DATE: November 21, 2016
TO: Development Review Committee
FROM: Ashley Cornelison, Senior Planner
SUBJECT: November 29, 2016 DRC WORKSHOP

DRC#: 16-00144 (2nd Review)

Project Name: Hamilton at Lakeside

Re: Hamilton at Lakeside: DRC#16-00144
16-25-29-00U0-0016-0000
PUD Site Plan

DRC SITE PLAN

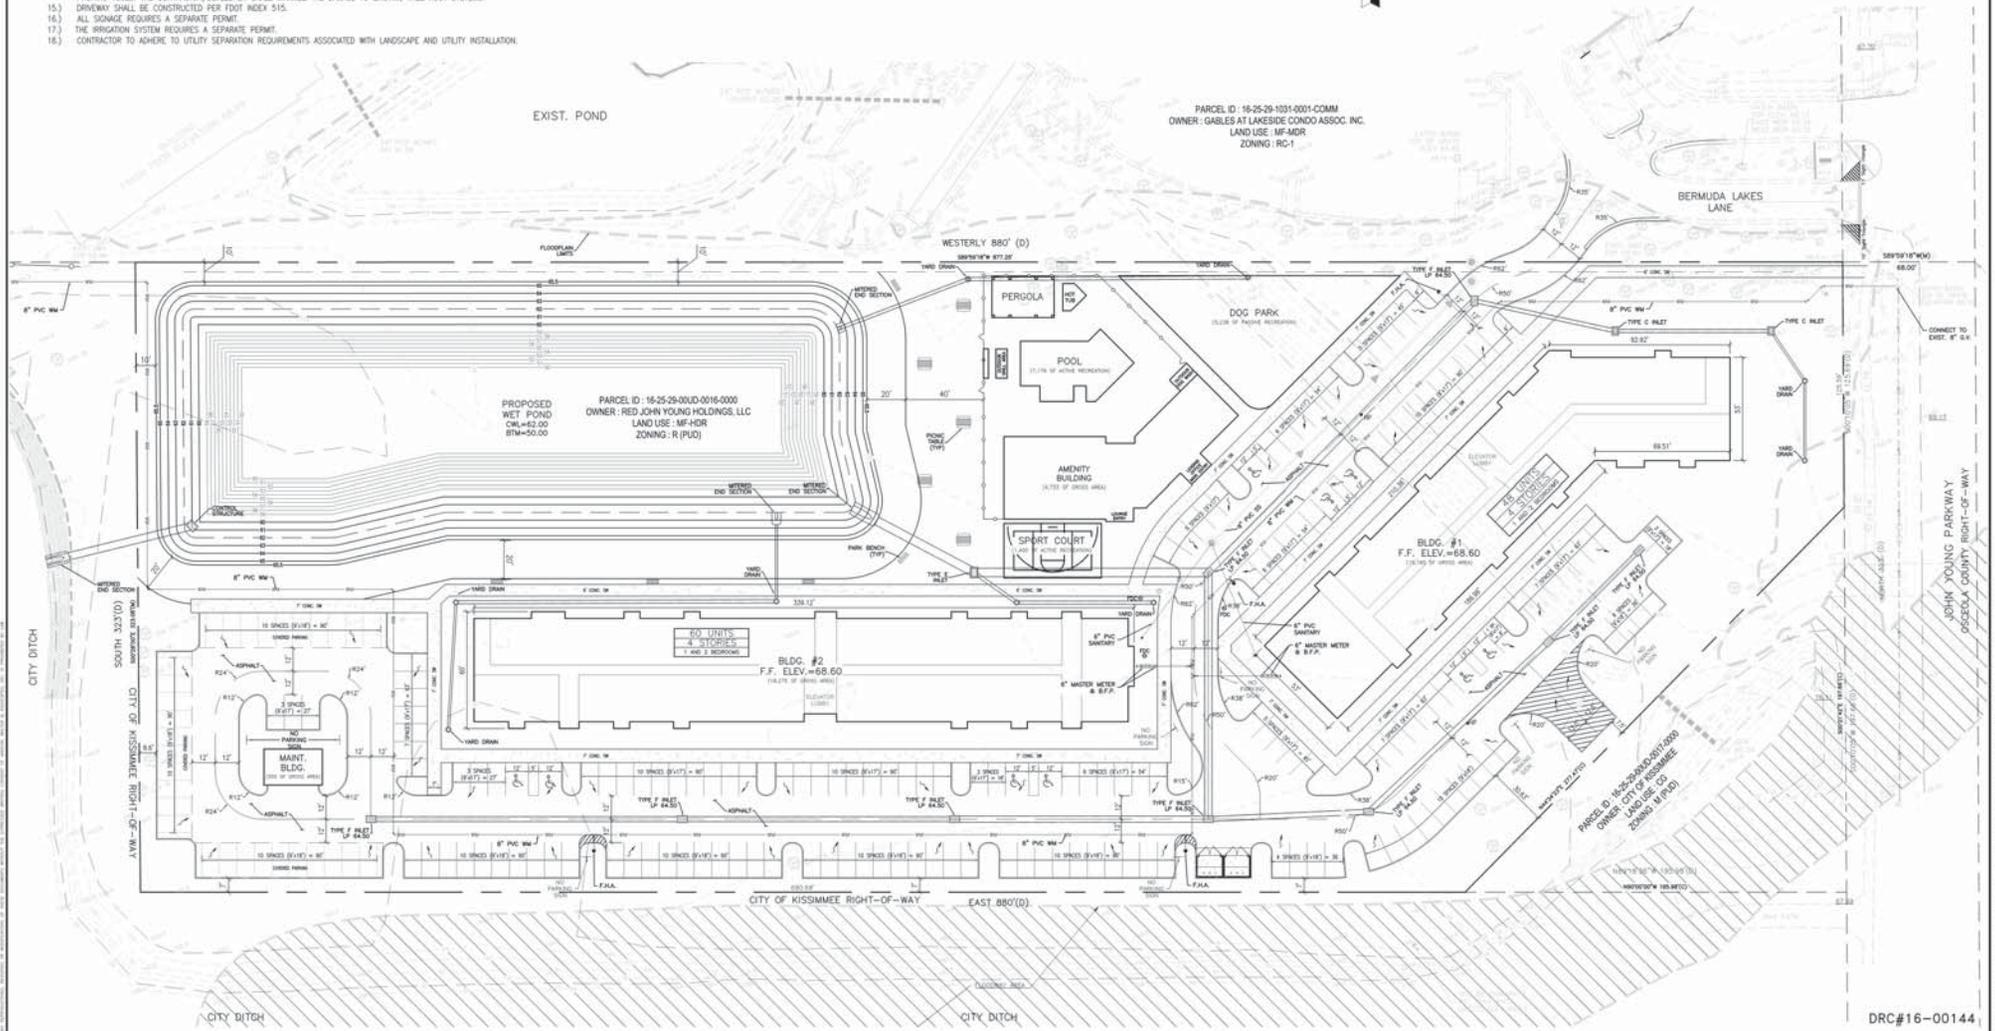
5. Please show location of the FDC (fire department connection) on the site plan. Fire Department connections for fire sprinkler systems, standpipe systems, and combined systems shall meet the same standards as those for fire hydrants and undergrounds which are applicable to the FDCs. For NFPA 13 systems, a hydrant shall be place within 250 feet of an FDC and the FDC shall be a minimum of 30 feet from the building. The FDC for 13R systems shall be located on an exterior wall of the building at the riser with no specific distance from a hydrant. LDC 14-2-138(I).

- 8. Per FFPC, NFPA 1, Uniform Fire Code, Florida 5th Edition, Chapter 18, Sub-section 18.2.3.5.3. Please add to "No Parking" detail; distances between No Parking signs cannot exceed 60'. Signs may alternate sides of road at 60' intervals (120' between signs.) Fire lanes shall be marked with freestanding signs with the wording, "NO PARKING FIRE LANE BY ORDER OF THE FIRE DEPARTMENTZ" or similar wording. Such signs be 12in. by 18in. with a white background and red letters and shall be a maximum of seven feet in height from the roadway to the bottom part of the sign. The signs shall be within sight of the traffic flow and be a maximum of **60 feet** apart.

12. There is a building on the southwest corner of this development labeled "M."
Please clarify what that building is.

23. There are two 12.5-foot spaces on the southeast corner of the property. Please clarify what these are for.

4. Please rotate or move the dumpster enclosure to provide a minimum 40' straight-in approach.

Please see revised plan enclosed for the fire department connections.

Per DRC meeting on November 8th, 2016, the” No Parking” signs have been added to the plans.

This is proposed to be a maintenance building. The callout for the building has been revised.

Please see revised plan enclosed.

1 AMENITY BUILDING - SOUTH/SOUTHWEST ELEVATION
A-3 1/16"=1'-0"

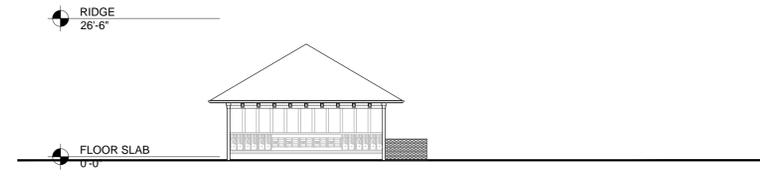
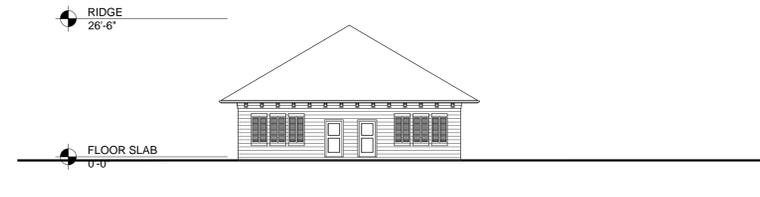
6. Providing building elevation plans (front, side & rear), including building height(s), to ensure acceptable design and compatibility with Code and the surrounding properties. Where a building is proposed that is larger in mass and scale than buildings adjacent to the site, facades, rooflines, and architectural features in the entry porticos, window openings, awnings, canopies, etc., shall be designed in a manner that will provide visual relief and sure consistency with the mass, scale and character of surrounding buildings. Architectural style, building materials, colors, and design features should serve to upgrade and enhance the surrounding area. Any façade visible from a public right-of-way shall have windows or other design features to avoid blank unbroken walls. In addition, show where all outdoor mechanical equipment including roof equipment is located and indicate by which means said equipment will be screened from view. 14-2-65(M); 14-2-195(I); 14-2-65(J)(1); 14-2-65(O)
